RE: Nolte Pit, File No. M-2012-016 , Technical Revision (TR-3) Adequacy Review

Nolte Pit #1
Puckett Land Company

Reclamation Plan Update
for 2018

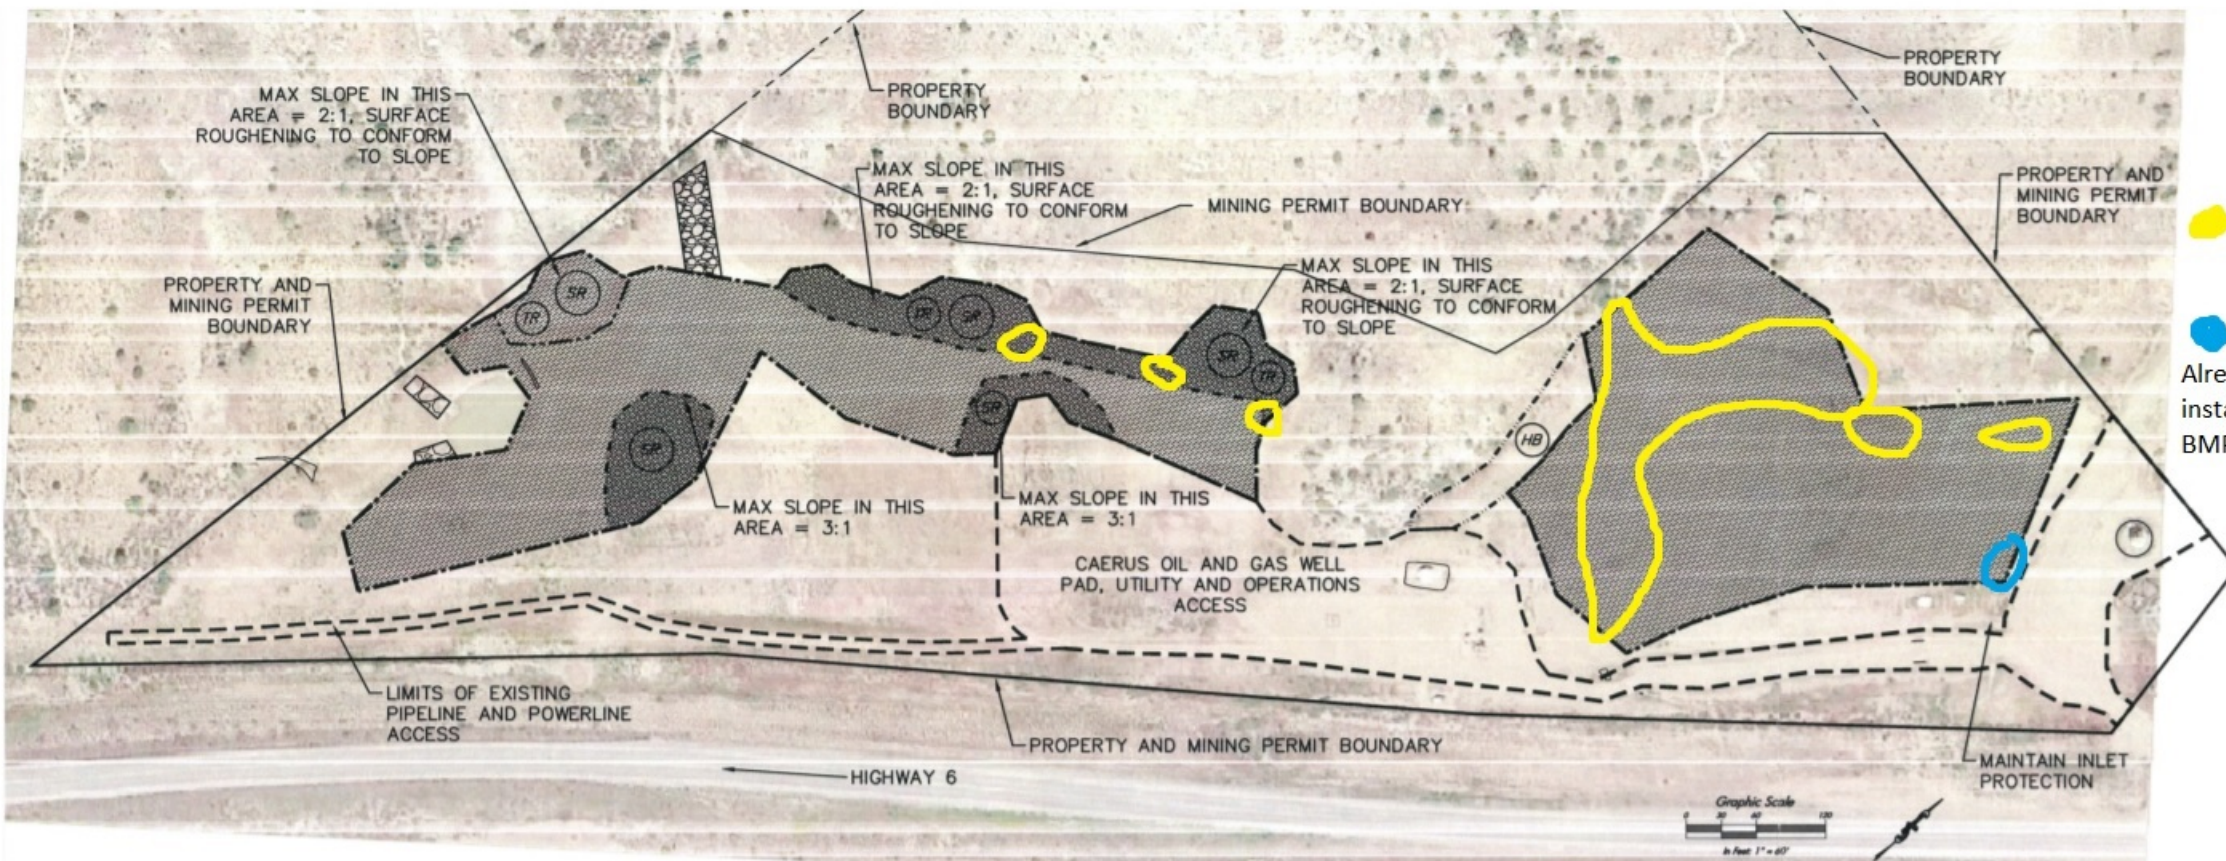
- The request references a change to the seed mix. However there appears to be no changes from the seed mix approved under TR-2. Please clarify this.
- Previous discussions have mentioned removing the remaining terraces and replacing them with other surface roughening techniques such as micro-pocketing. Both, in the narrative and on the map, terraces are still apart of the reclamation plan. Please clarify which method is to be used.

- I.e. will the seed be coated, fertilizer tilled into the soil prior to seeding, added to hydromulch slurry and applied, etc.
- Under Discussion of Application Methods and Acreage of Such-Mulch Spreading:
 - It was previously specified that Ecoflex is to be used in all areas except those areas hand broadcasted. Item #2. States that drill seeded areas will not be mulched. These are conflicting statements. Please clarify.
- The Division notes that the only changes to the 2018 map is the soil treatment narrative. Please provide additional information on the map to show revegetation and storm water management discussed below.

- Attached is your map with specific areas of concern from the December inspection highlighted (Yellow) where run-on has created significant erosion problems on site. Storm water BMPs were observed during the inspection but are not depicted on the reclamation map, these areas are highlighted (Blue).

Need BMP
Already installed BMP
